**re: Grading and Site Servicing Review**  
**Proposed Industrial Development**  
**6160 Thunder Road, Ottawa, Ontario**

**date: August 12, 2024**

**file: PG5161-MEMO.04 Revision 1**

**C301**

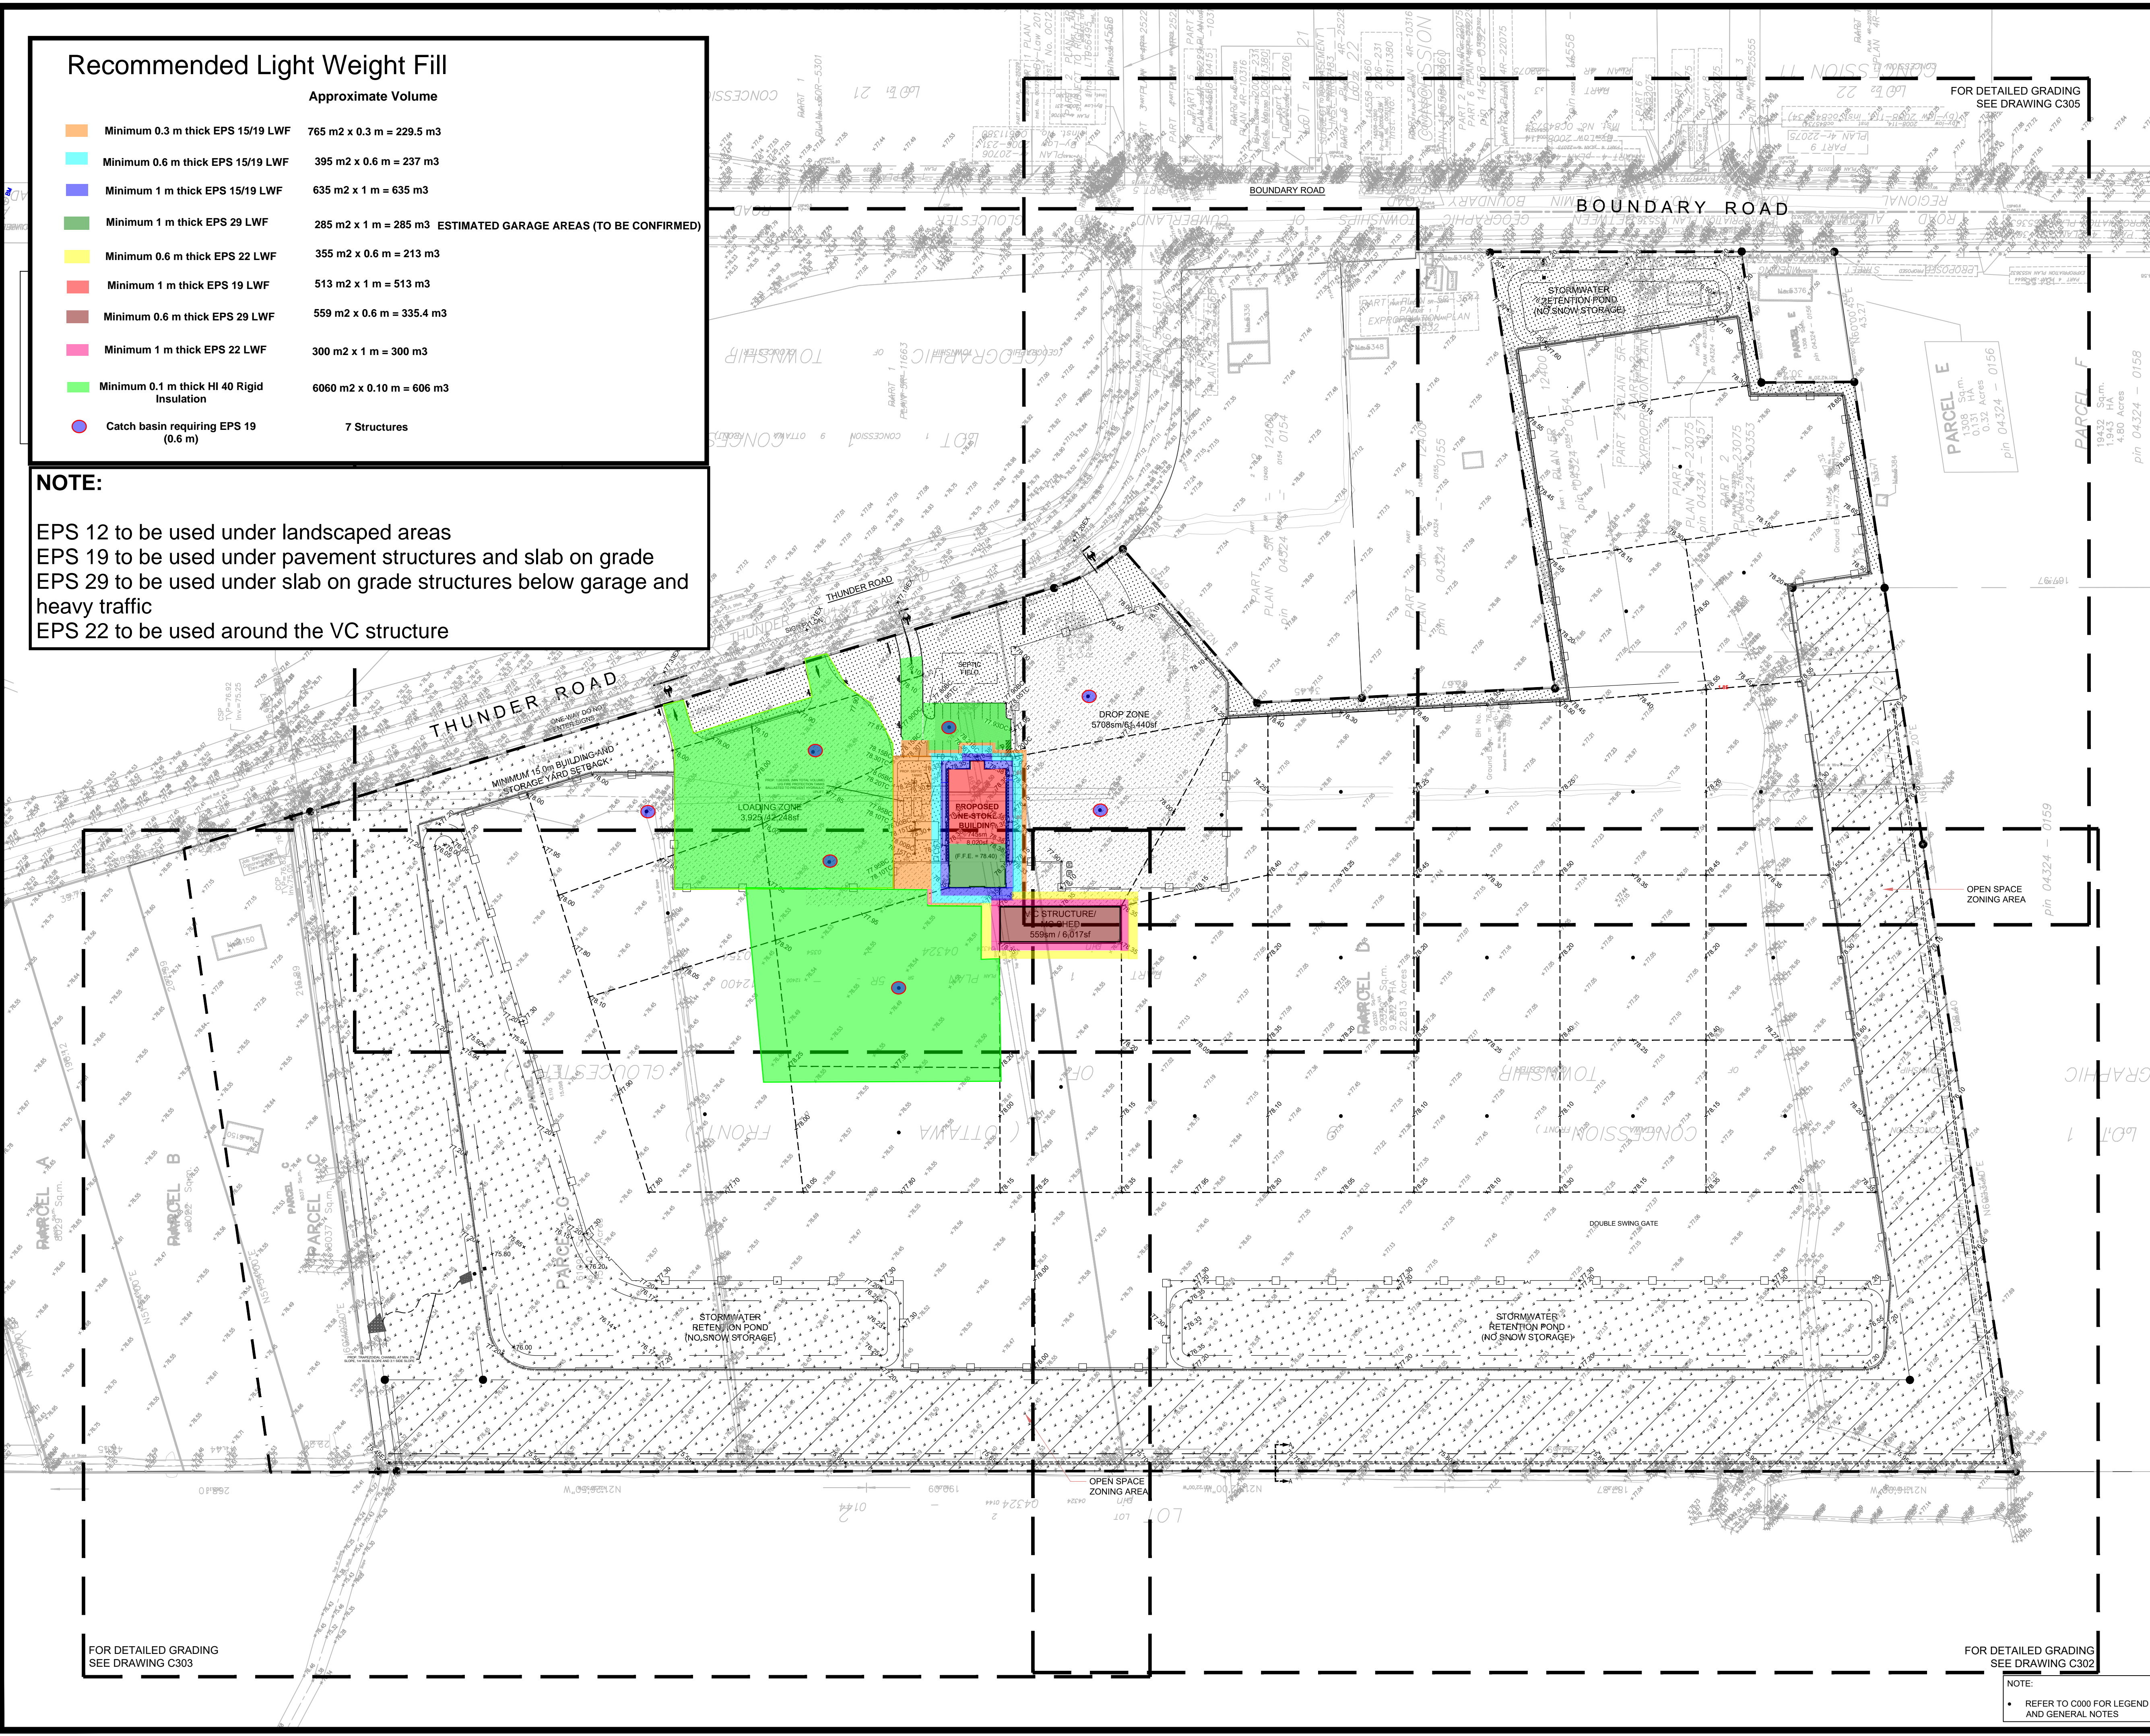
Based on our review of the above-noted drawing, the proposed grading for the Industrial building and the VIC Structure exceeds the permissible grade raise recommendations provided in the geotechnical report. Our grading summary and lightweight fill recommendations are presented in Table 1 – Soil Matrix Summary attached.

Below the pavement and landscaped areas, the LWF EPS blocks should be comprised of EPS 19 and EPS 15 blocks respectively and should be placed as per the marked-up site plan attached to the end of this memorandum.

Due to the smaller permissible grade raise exceedance in the paved an storage area, a settlement surcharge program can also be conducted within the noted areas in light green (refer to attached mark-up) on the attached site plan. It is recommended to pre-grade the proposed parking and storage areas with approved fill and surcharge the area to a minimum of 0.6 m over the proposed final grade, over an anticipated period of six (6) to eight (8) months. Paterson shall monitor the settlement of the ground to confirm settlement rates and completion of the surcharge program. The completion of a successful surcharge program would eliminate the need for LWF within these areas.

In the gravel storage area, it is expected that approximately 25 to 50 mm of settlement can be expected over time. Therefore, the to maintain minimum drainage slope along the servicing lines some catchbasins will require LWF. A minimum of 0.6 m of EPS 19 extending 1.2 m around the catchbasin should be used to protect the structures as indicated on the attached plan.

Approximate Volume
Minimum 0.3 m thick EPS 15/19 LWF	765 m <sup>2</sup> x 0.3 m = 229.5 m <sup>3</sup>
Minimum 0.6 m thick EPS 15/19 LWF	395 m <sup>2</sup> x 0.6 m = 237 m <sup>3</sup>
Minimum 1 m thick EPS 15/19 LWF	635 m <sup>2</sup> x 1 m = 635 m <sup>3</sup>
Minimum 1 m thick EPS 29 LWF	285 m <sup>2</sup> x 1 m = 285 m <sup>3</sup> ESTIMATED GARAGE AREAS (TO BE CONFIRMED)
Minimum 0.6 m thick EPS 22 LWF	355 m <sup>2</sup> x 0.6 m = 213 m <sup>3</sup>
Minimum 1 m thick EPS 19 LWF	513 m <sup>2</sup> x 1 m = 513 m <sup>3</sup>
Minimum 0.6 m thick EPS 29 LWF	559 m <sup>2</sup> x 0.6 m = 335.4 m <sup>3</sup>
Minimum 1 m thick EPS 22 LWF	300 m <sup>2</sup> x 1 m = 300 m <sup>3</sup>
Minimum 0.1 m thick HI 40 Rigid Insulation	6060 m <sup>2</sup> x 0.10 m = 606 m <sup>3</sup>
Catch basin requiring EPS 19 (0.6 m)	7 Structures

**NOTE:**  
 EPS 12 to be used under landscaped areas  
 EPS 19 to be used under pavement structures and slab on grade  
 EPS 29 to be used under slab on grade structures below garage and heavy traffic  
 EPS 22 to be used around the VC structure
